GRP2601(P)/2602(P/W)/2603(P)/2604(P) Firmware Release Notes

FIRMWARE VERSION 1.0.1.41

GRP2601(P), GRP2602(P/W), GRP2603(P), GRP2604(P)

3/25/2021

ALLOW MULTIPLE ACCOUNTS

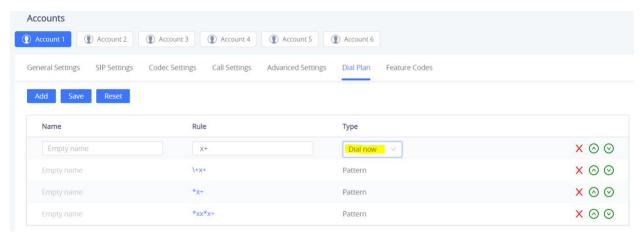
Now users are able to configure remaining account with a SIP account and be able to make/receive calls on the configured account even if the user is not logged in to the public mode.

- If set to "No", then after the user logs in to the public mode account on LCD, only the public mode account can be used on the phone even though there are other configured SIP accounts
- If set to "Yes," then after the user logs in to the public mode account on LCD, other configured SIP accounts on the phone can also be used. Note: This option requires enabling public mode to take effect.

Pvalue	Description	Value Range	Default
8564	<new pvalue=""></new>	Value = 0; No	No
	Allow Multiple Accounts	Value = 1; Yes

DIAL NOW TYPE

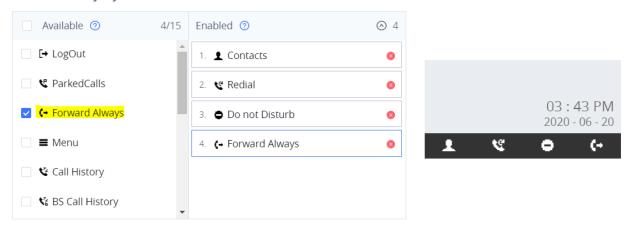
With this "Dial now" type, the rules you set in combination with this type will be dialed out once the DTMF matches the dial plan.
